**Maine Maritime Academy  
Castine, Maine**

**Pier Upgrades and Waterfront Improvements Project  
March 22, 2024  
ADDENDUM NO. 6**

**SHEET E-203 GENERAL NOTES**

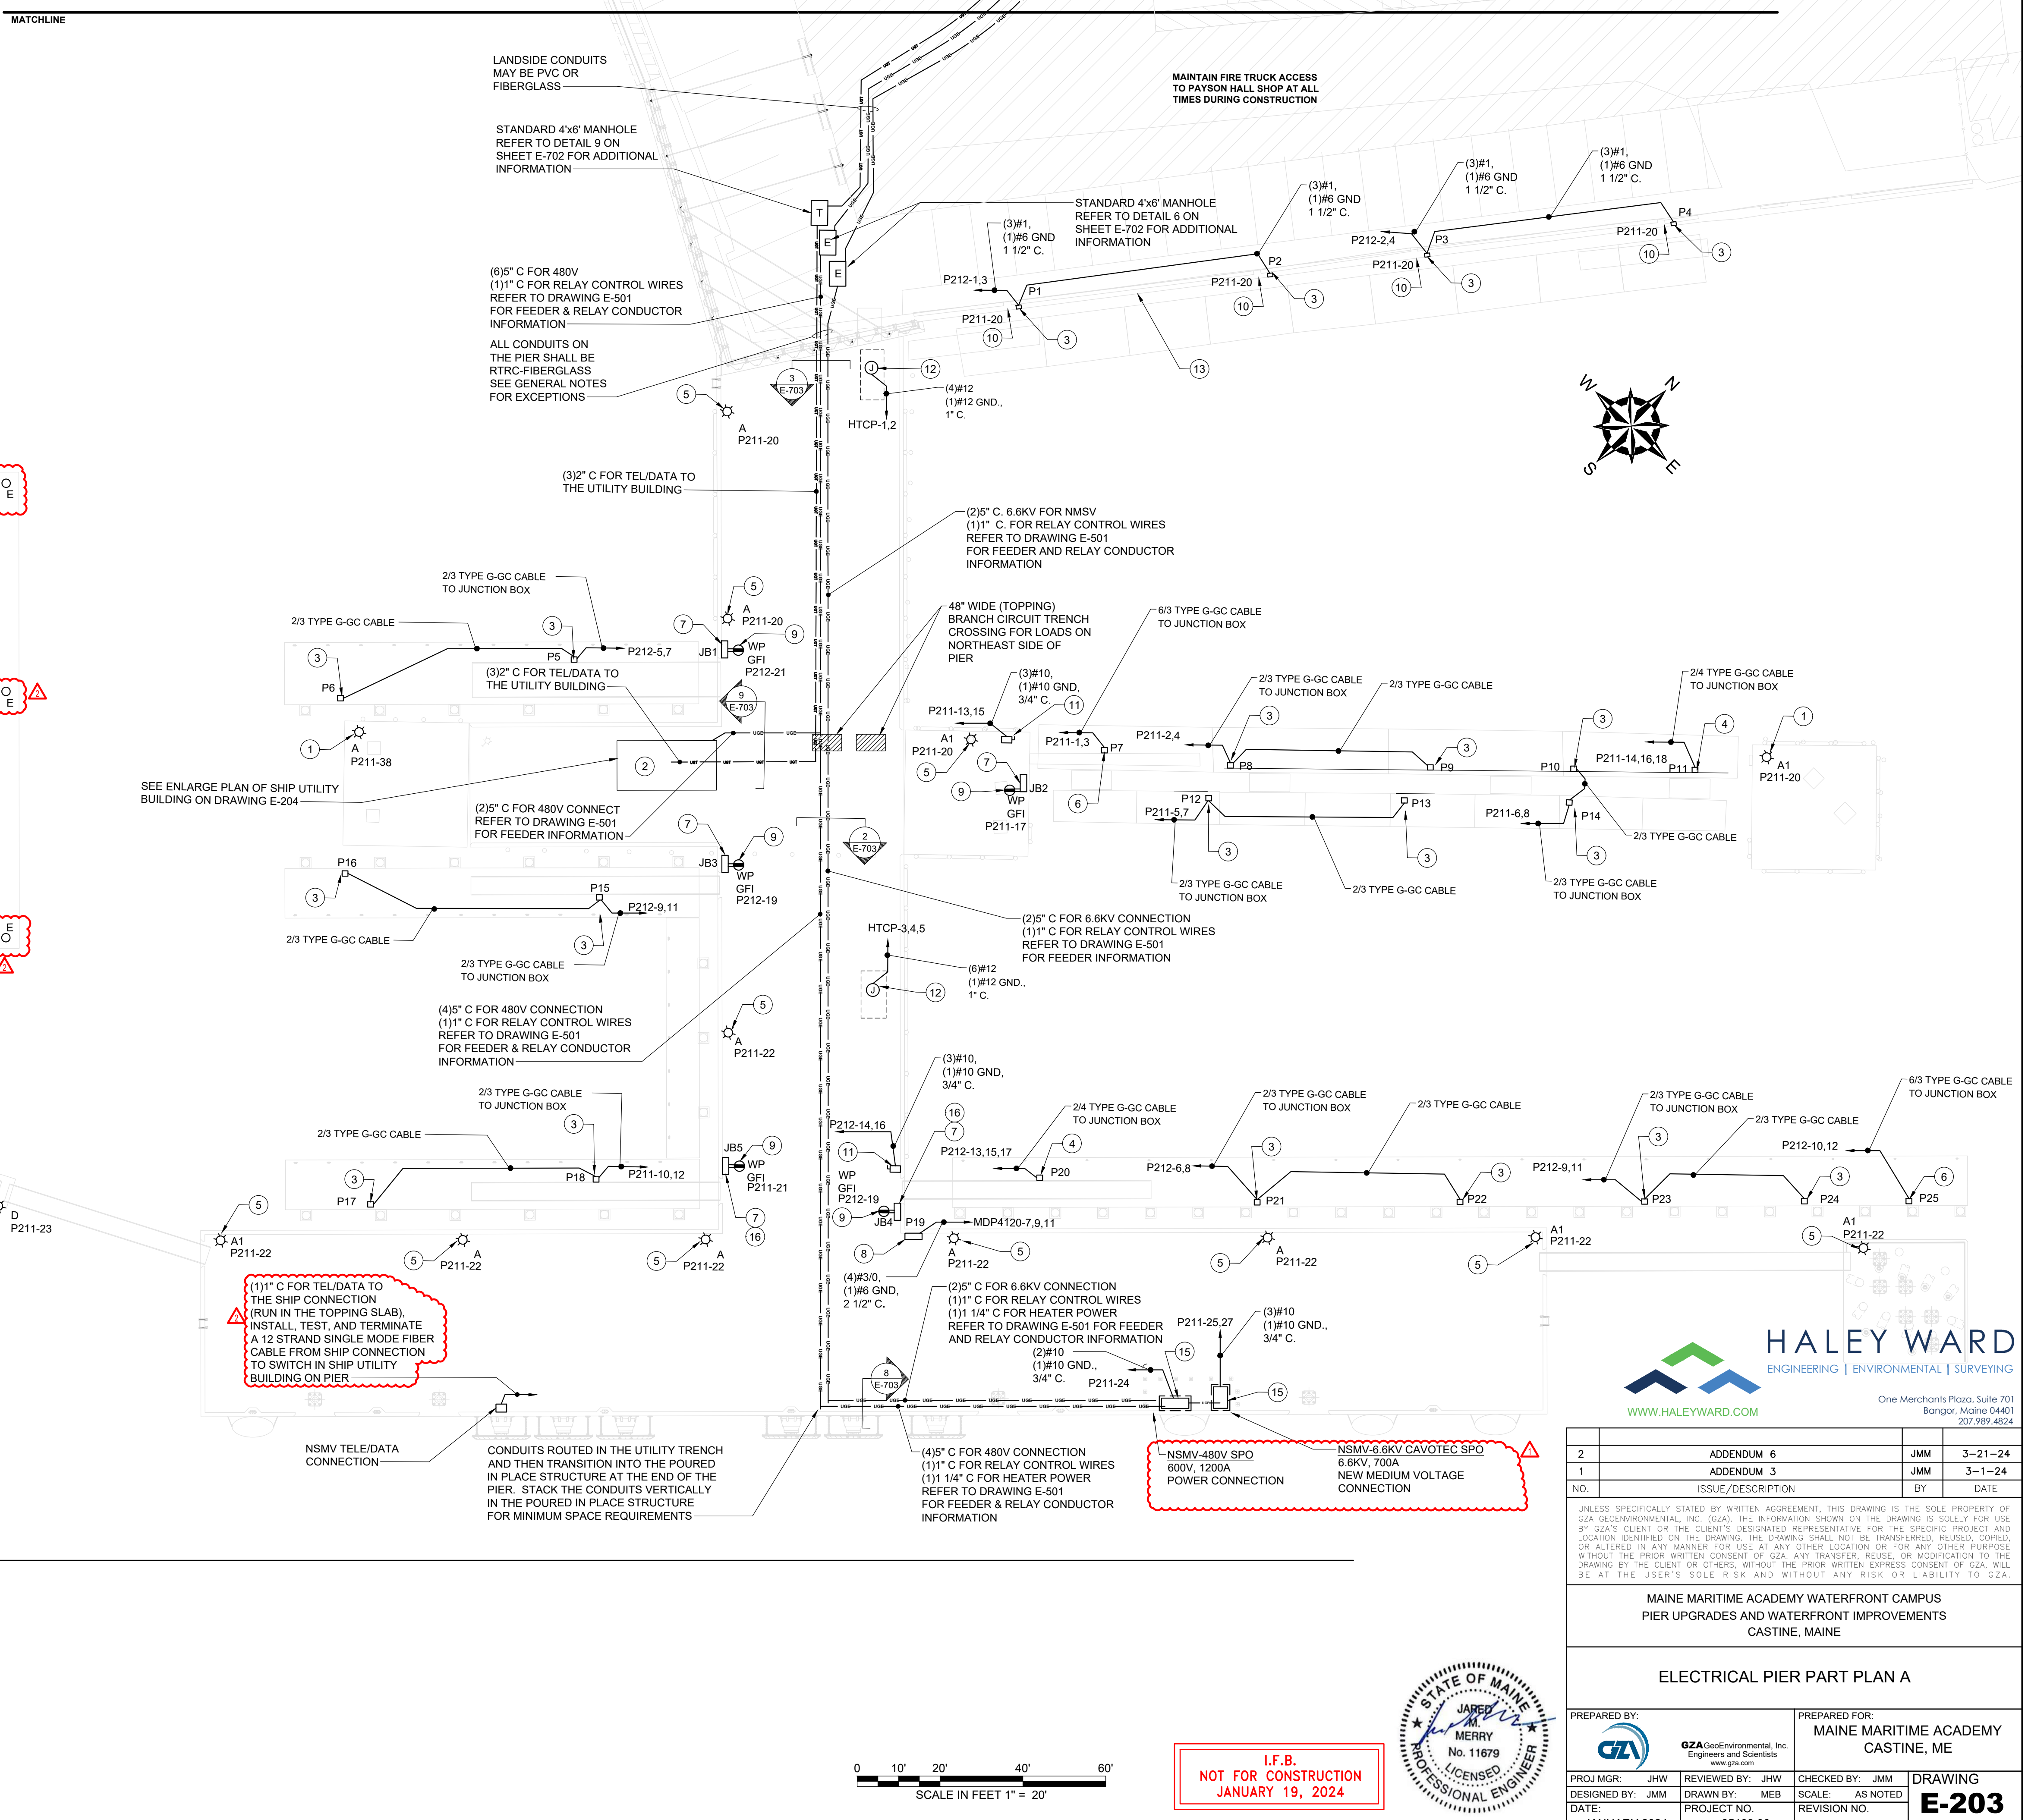
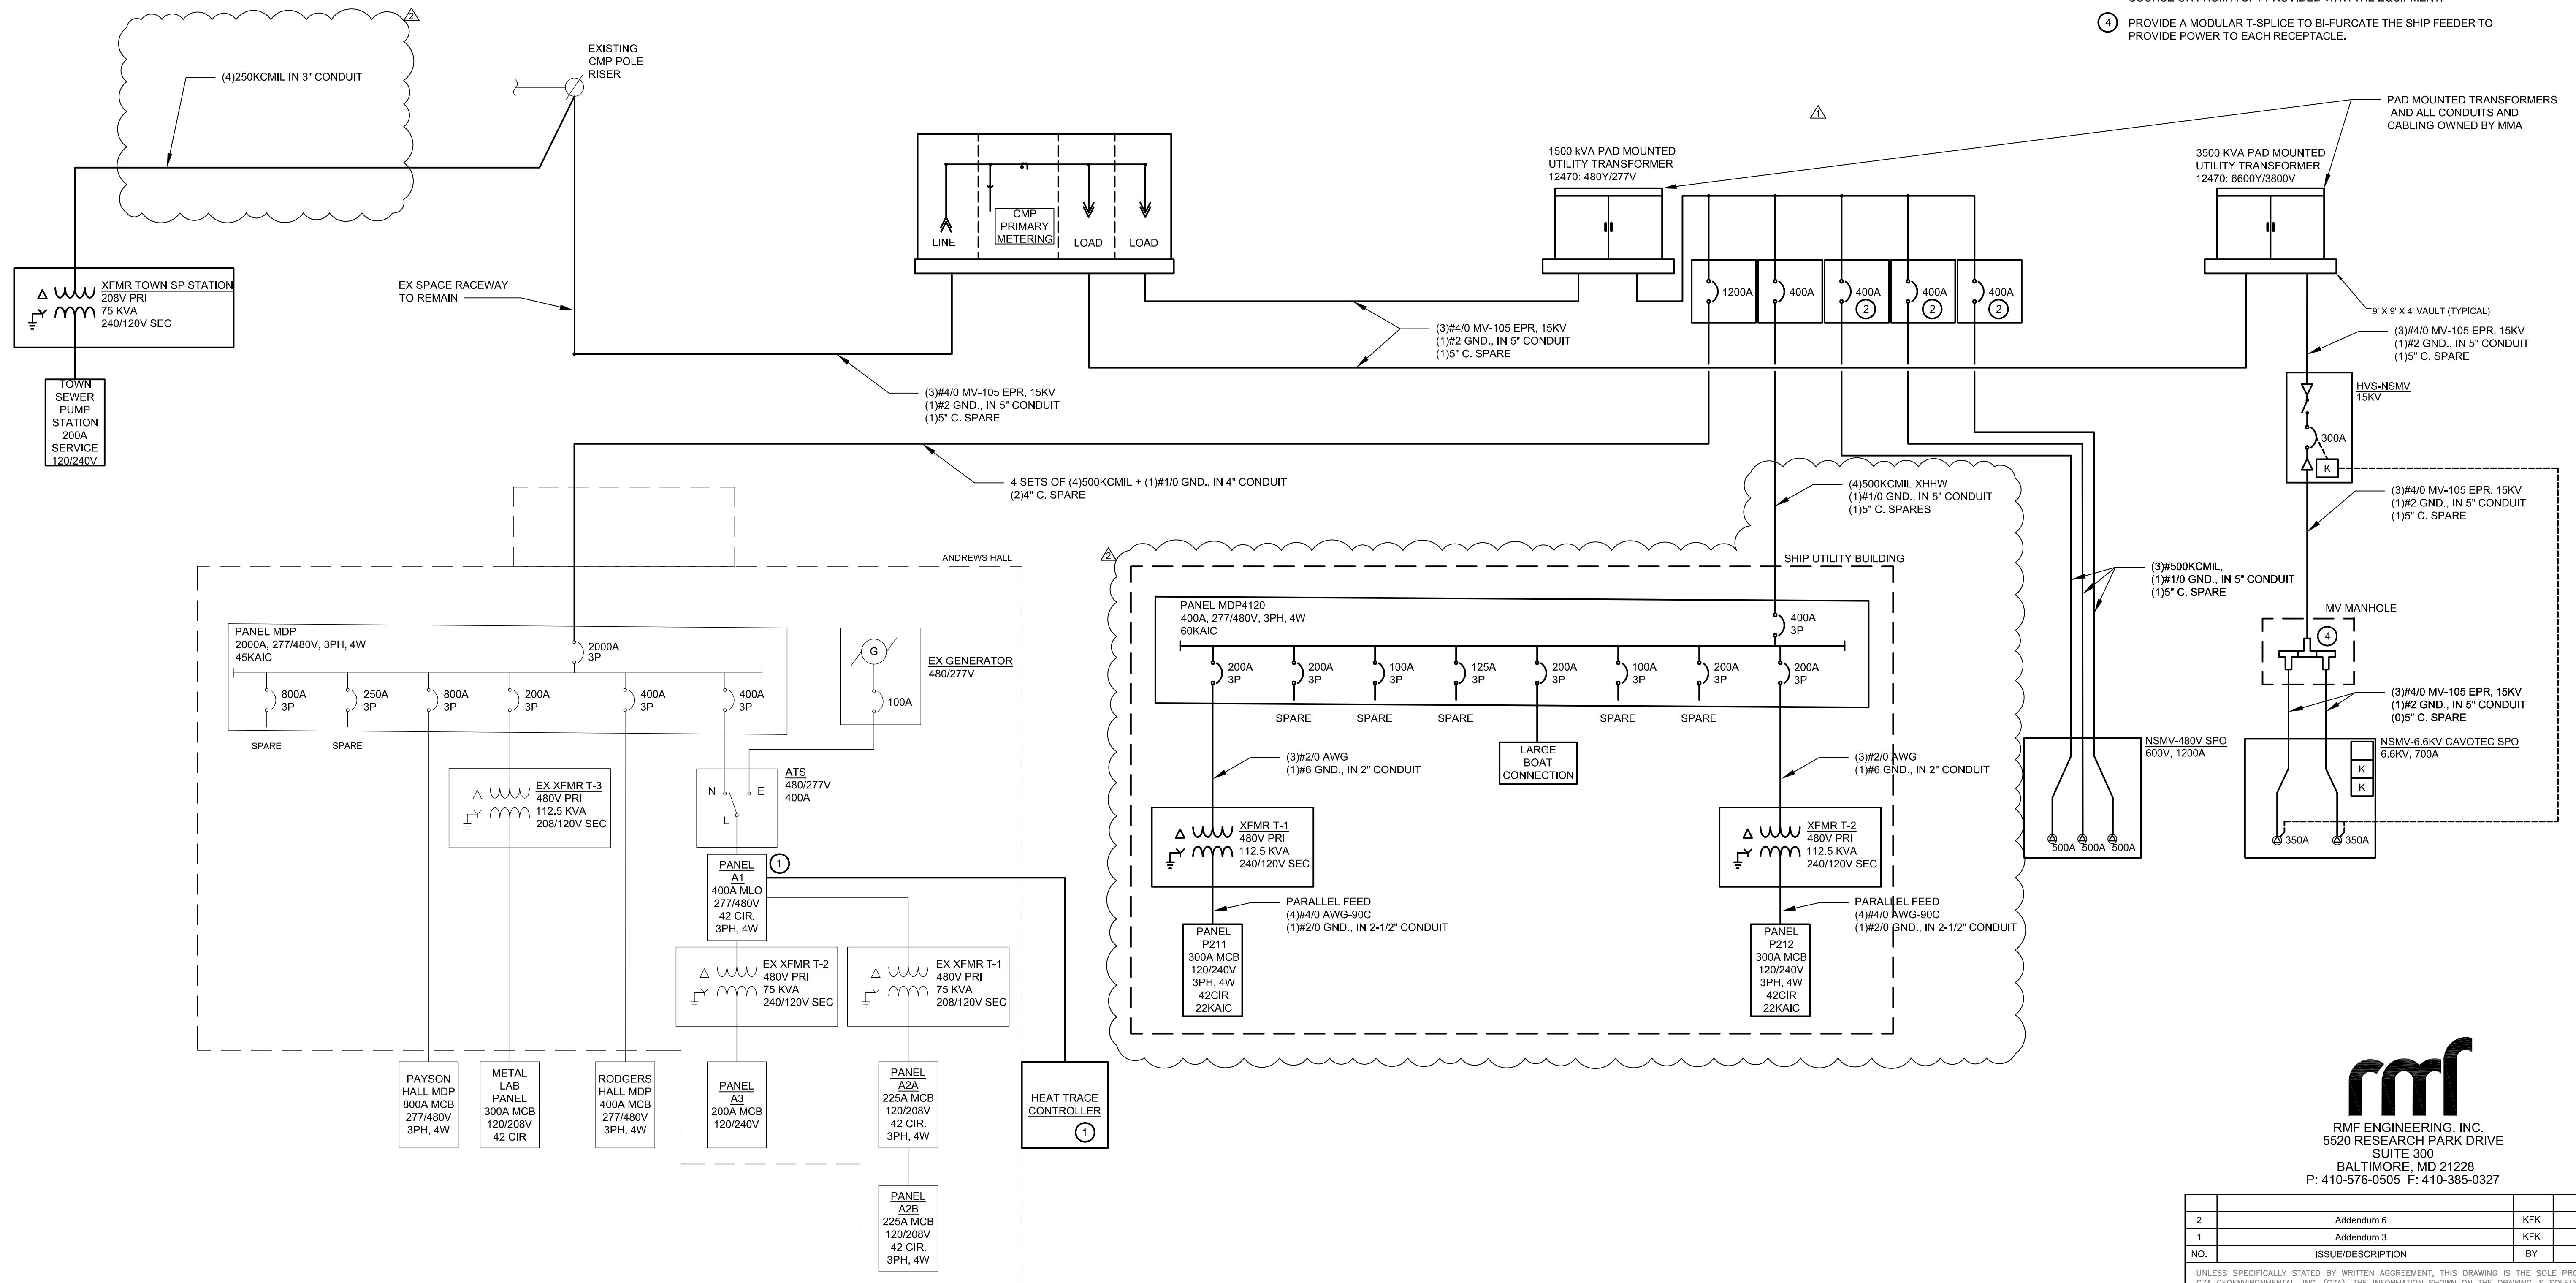
29. IFB E-703: Pier trench Detail 2, conduit #11 does not indicate what data cabling is required. Please advise.

30. IFB E-801: in the Marine Pedestal schedule it lists P-19 as an Admiral Power Surface Pedestal. On print E-203 note 8 it indicates that an Eaton Super Yacht Power Pedestal will be provided. Can you clarify which pedestal is desired?

Response 29: See the attached re-issued IFB Drawing E-203.

Response 30: Marine Pedestal P-19 is intended to be used for larger vessels. Disregard the Pedestal type in Note 8 on Sheet E-203. Pedestal P-19 as indicated in the schedule on Sheet E-803 is correct.
